UNITED STATES  
NUCLEAR REGULATORY COMMISSION  
WASHINGTON, D. C. 20555

Docket No. 50-395

SUBJECT: SUMMARY OF SITE VISIT AND REQUEST FOR ADDITIONAL INFORMATION

### SUMNER STATION SITE VISIT SUMMARY

FIGURE 1 EFS FLOW SCHEMATIC

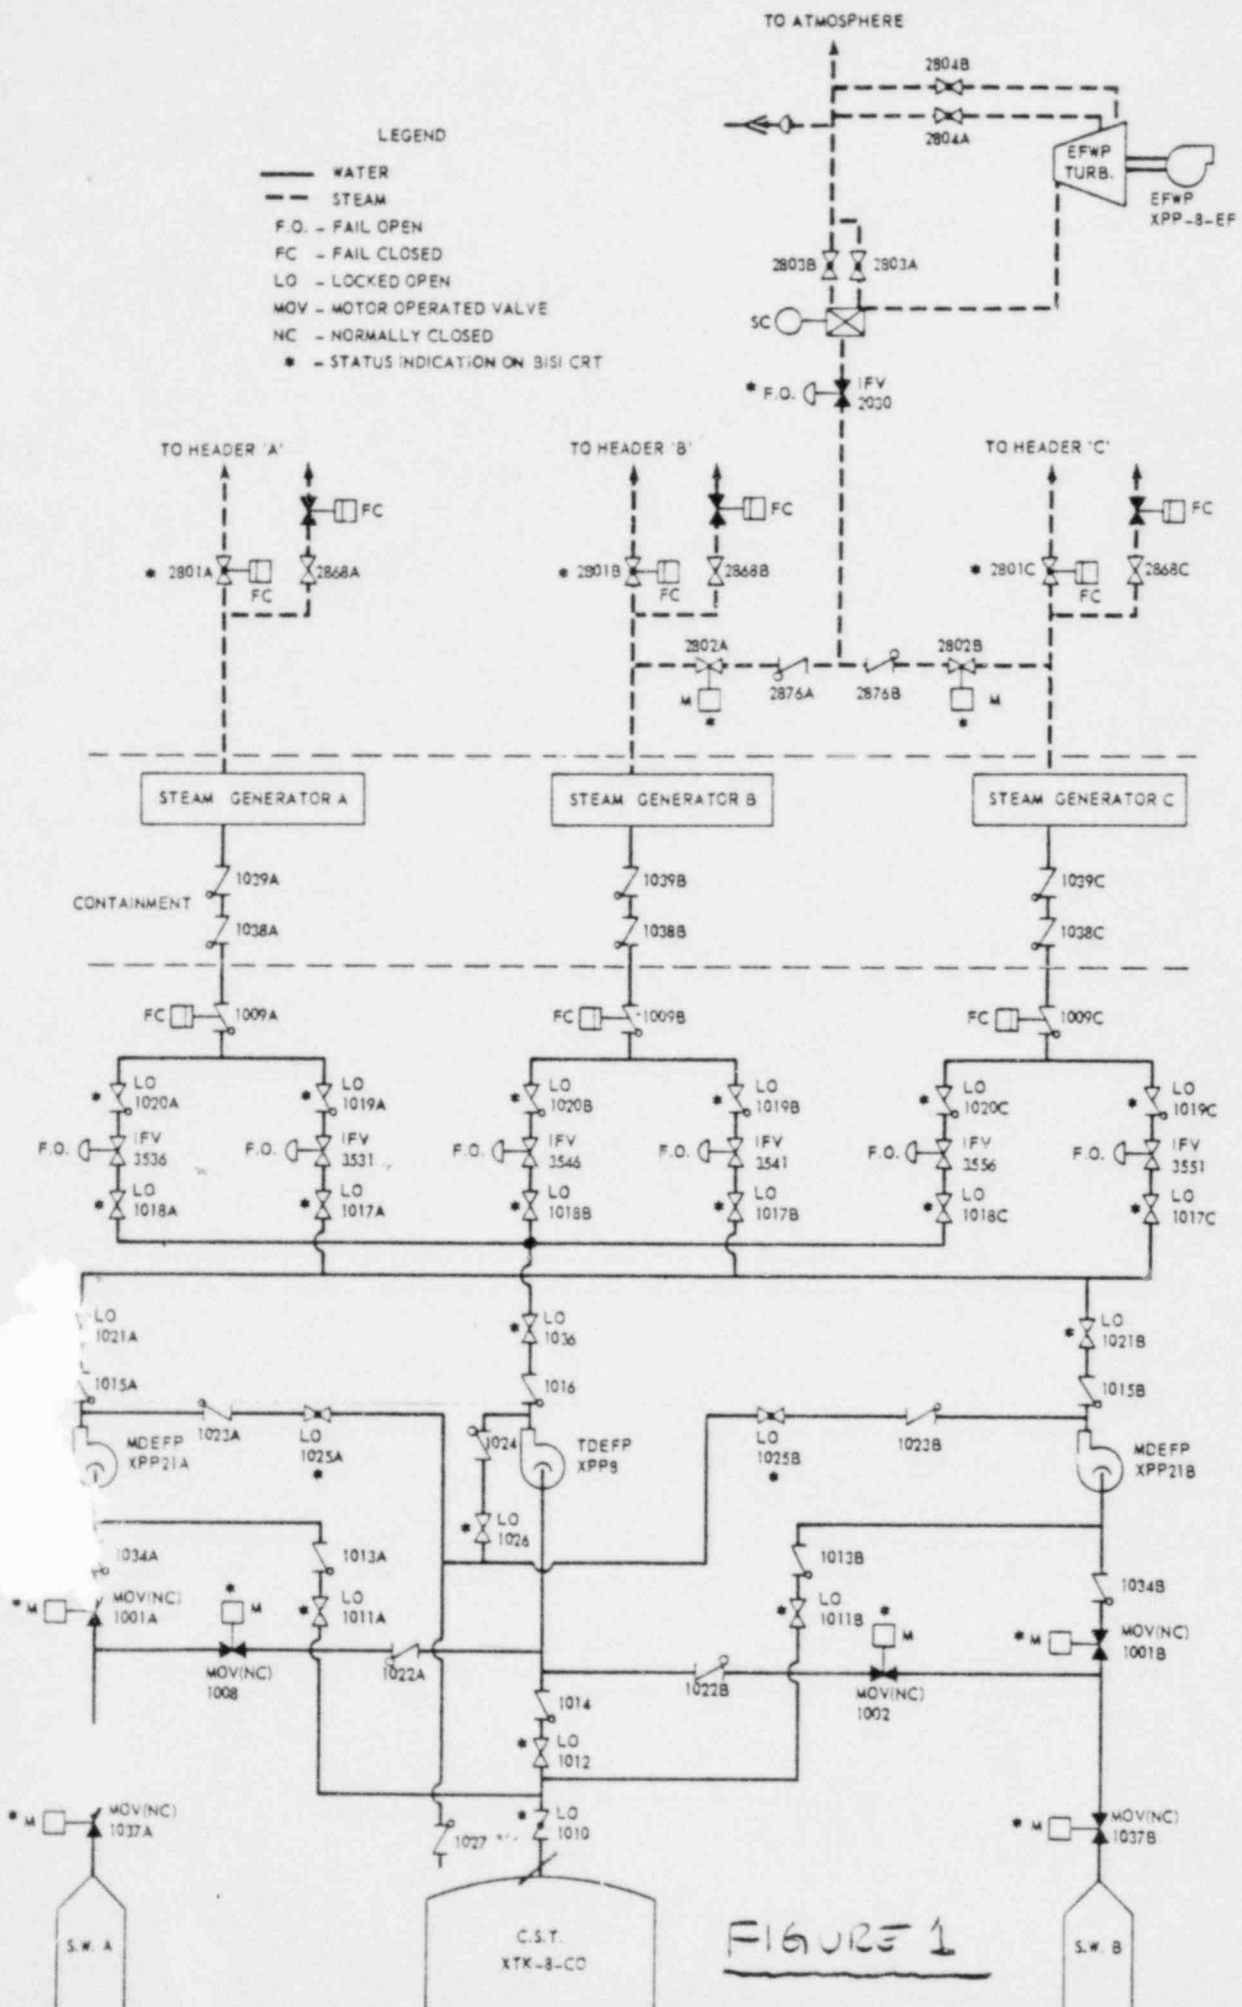
During the review of the Auxiliary Feedwater (AFW) System, we noted a number of concerns related to the control and protection aspects of the system design. The following discussion of the design of the AFW system is provided to clarify these concerns. Figure 1 is a simplified schematic of the AFW system. The two motor driven feed pumps (MDFPs) supply a common header with a separate feed to each steam generator. The turbine driven feed pump (TDFP), likewise, supplies a header, with a separate feed to each steam generator. A control valve is provided in each of the two separate feeds to each steam generator (e.g., IFV-3536 and 3531 for steam generator "A" in Figure 1). The control valves fulfill two safety functions. The first is to permit manual control of auxiliary feedwater flow to maintain the desired steam generator level for safe shutdown. The second is to permit manual isolation of a steam generator on feed-water/steam line breaks to protect the containment from over pressurization and to assure an adequate supply of auxiliary feedwater for the remaining steam generators for safe shutdown.

The air operated control valves are supplied air from the control-grade instrument air system and fail open on the loss of instrument air. Thus, on a loss of the non-safety instrument air system, the safety function to regulate AFW flow can only be accomplished via local operation of the handwheels on the control valves or by cycling the MDFP and throttling the TDFP speed. With instrument air available, the regulation of AFW flow is dependent upon the availability of electrical power

to the valve controls. As in the case of loss of air, the control valves fail open on the loss of electrical power to the control system. The control valves fed by the MDEPs are supplied power from a power source which is independent of the power source used to supply power to the control valves fed by the TDFP. Thus, a loss of an electrical power source would only prevent the capability to regulate AFW flow from one of the two sources of AFW. The power source dependence for the automatic initiation of the AFW system is such that a loss of an electrical power source would not prevent starting of the TDFP or one of the two MDEPs. Therefore, a loss of an electrical power source which could cause the control valves, associated with either the MDEPs or TDFP, to fail open, should not present a situation in which the safety function to regulate AFW flow cannot be maintained. For this event, termination of flow to the failed open control valves would require that the pump(s) associated with that water source be tripped. This capability exists for the MDEPs. For the TDFP, this capability is not straight forward. The TDFP is started by opening valve IFV-2030, see Figure 1. This valve is controlled by redundant dc power sources, the failure of either one cause the TDFP to start. These same power sources are used as the two power sources which would cause one or the other sets of control valves to fail open. Thus, the only means available to terminate steam flow to the TDFP would be the closure of the isolation valves from the two steam generators that feed the TDFP steam supply header. There are valves 2902A and 2902B in Figure 1 and operate from separate essential 400 volt buses.

FIGURE 2

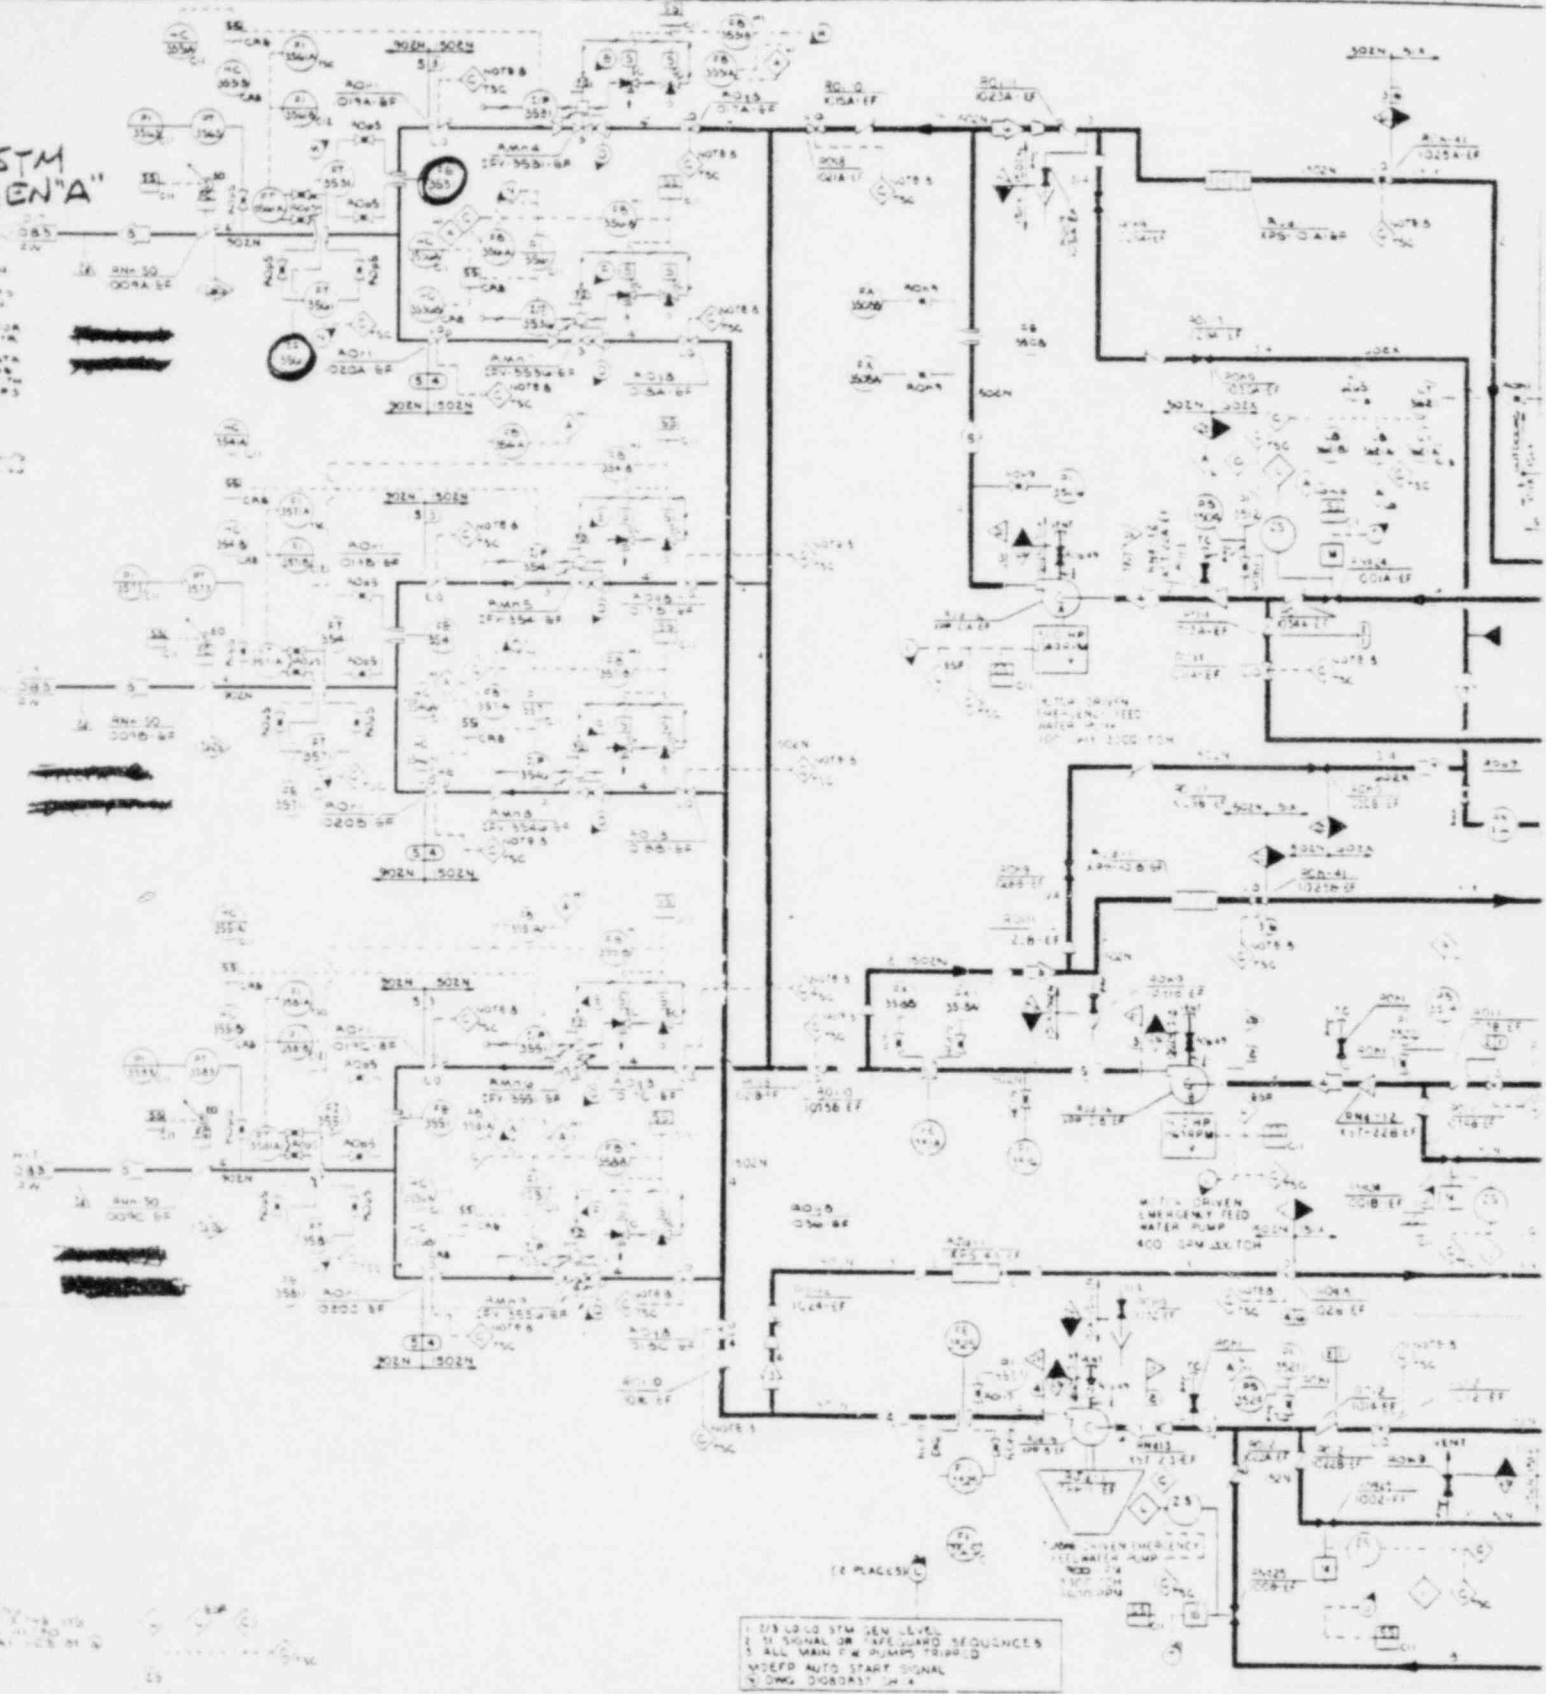
With respect to the safety function of the AFW control valves to permit isolation of a steam generator for feedwater/steam line breaks, a single channel system is provided to automatically close the AFW control valves on high AFW flow to a steam generator. Since this automatic isolation does not satisfy the requirements to be classified as a safety related system, i.e., it does not satisfy the single failure criterion, manual isolation of the steam generators is the means by which this safety function is accomplished. Nevertheless, the automatic isolation features are a system important to safety even though these do not satisfy all the requirements of a safety-grade protection system. Figure 2 is the P&I drawing of the AFW system. The control valves fed from the MDEP header are closed on high flow that is measured by a flow element located downstream of the control valves (FE-3531 for steam generator A in Figure 2).

The control valves fed from the TDFP header are closed on high flow that is measured by a flow element located in the feed line to each steam generator (FE-3561 for steam generator A in Figure 2). A time delay is included in the isolation circuits such the high flow condition must exist for 30 seconds before isolation is initiated. The set points for isolation on high flow are 600 gpm for the MDFP supply and 700 gpm for the total flow to the steam generator. In addition, a separate high flow alarm is provided for each flow measurement which is set at 50 gpm above the isolation set points. The automatic isolation signal for the control valves actuates a three-way solenoid valve that connects an accumulator air supply to the valve diaphragm to close the control valve. This arrangement is shown in Figure 3. The air accumulator is provided to assure the availability of an air supply to close the valve, since the normal air supply is from the non-safety grade instrument air system. As previously noted, the electrical power for the two control valves for each steam generator are provided from separate power sources. Thus, from a single failure view point, at least one of the two control valves would be automatically closed on a high flow condition. For this event, termination of flow to a faulted steam generator would require that the pump(s) associated with the other water source be tripped. This capability was discussed above.

FIGURE 3

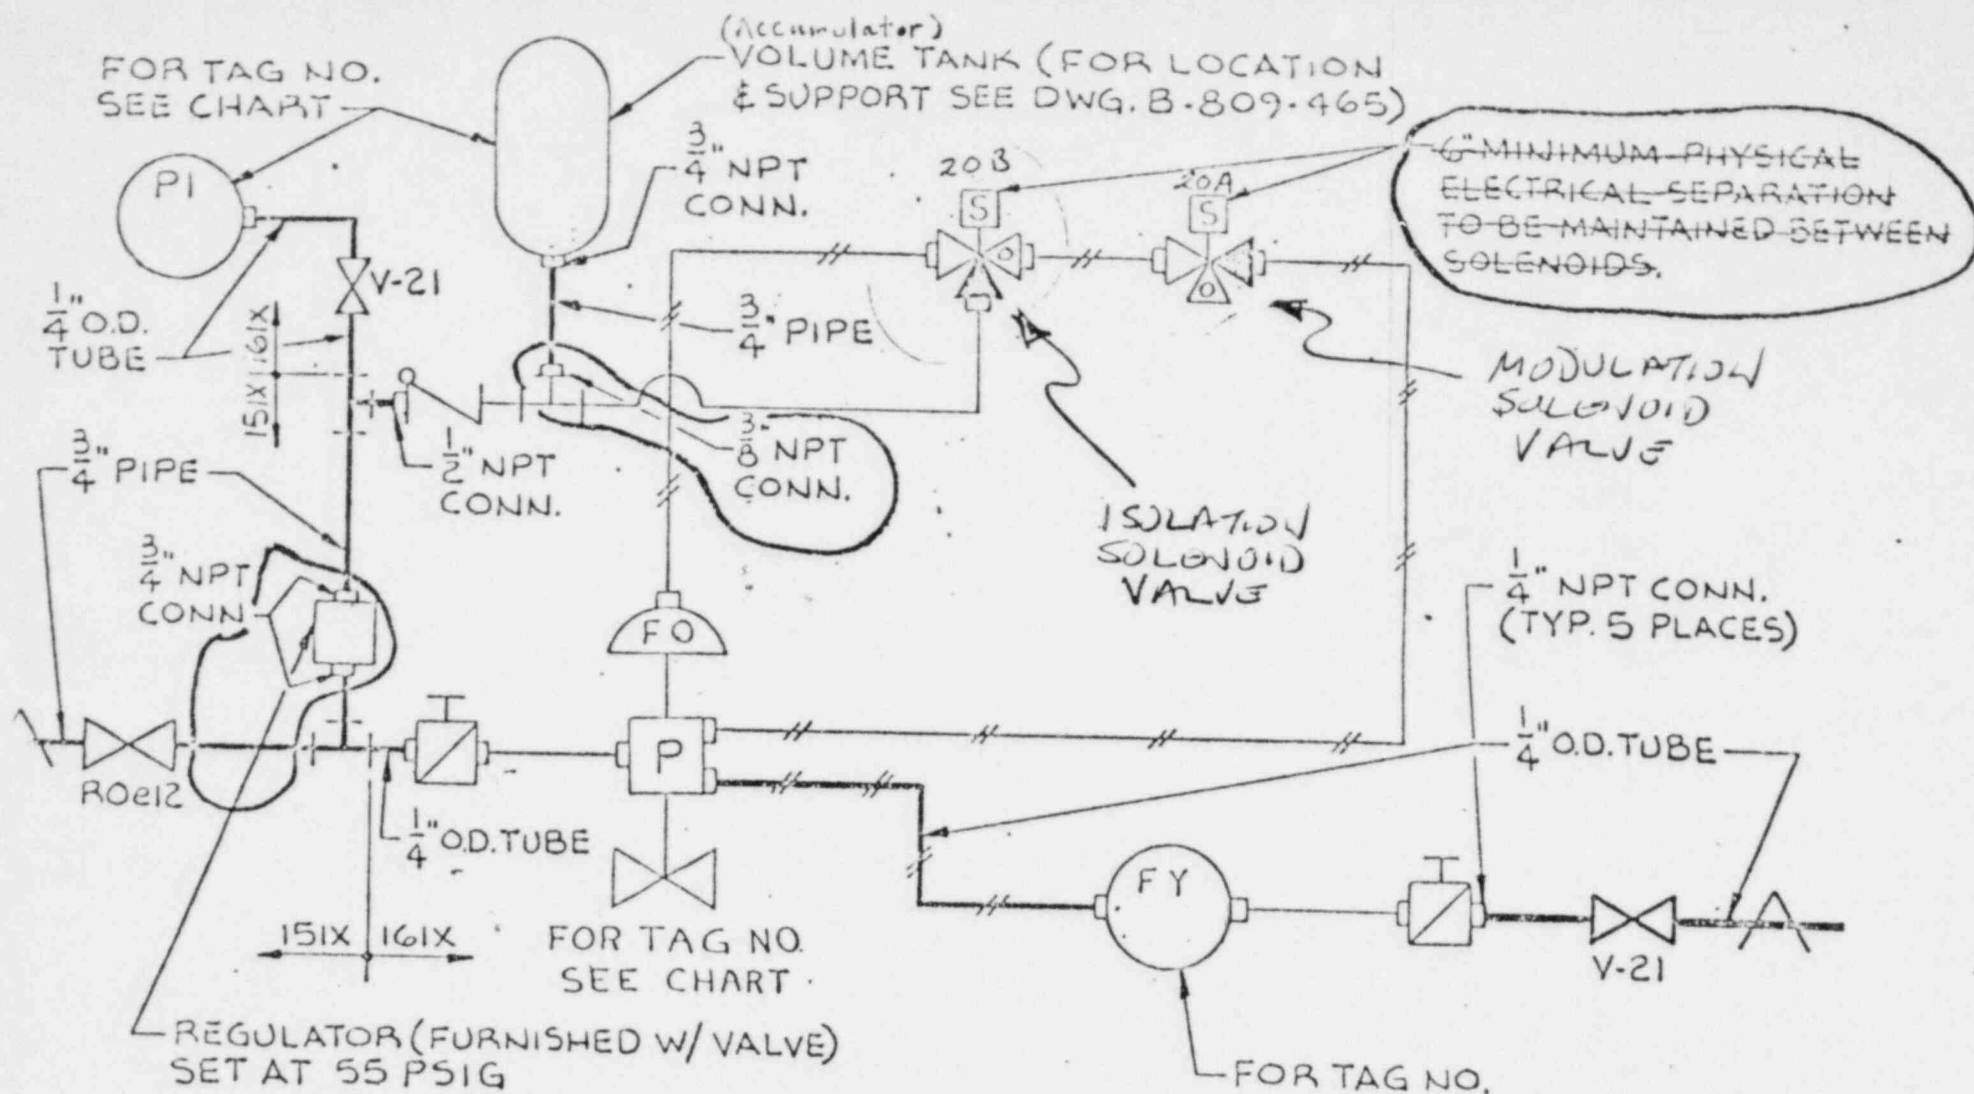
The accumulator for the closure of the AFW control valve is isolated from the non-safety related instrument air system by a check valve (See Figure 3). The operation of this check valve is essential for the availability of the air source to effect valve closure.

The accumulator air system for the AFW control valves should be modified to permit periodic testing of the operability of the accumulator system. The technical specification should include surveillance requirements for the accumulator system and the operability of the manual valve closure capability of the control valves on a schedule consistent with that used for safety related valves.
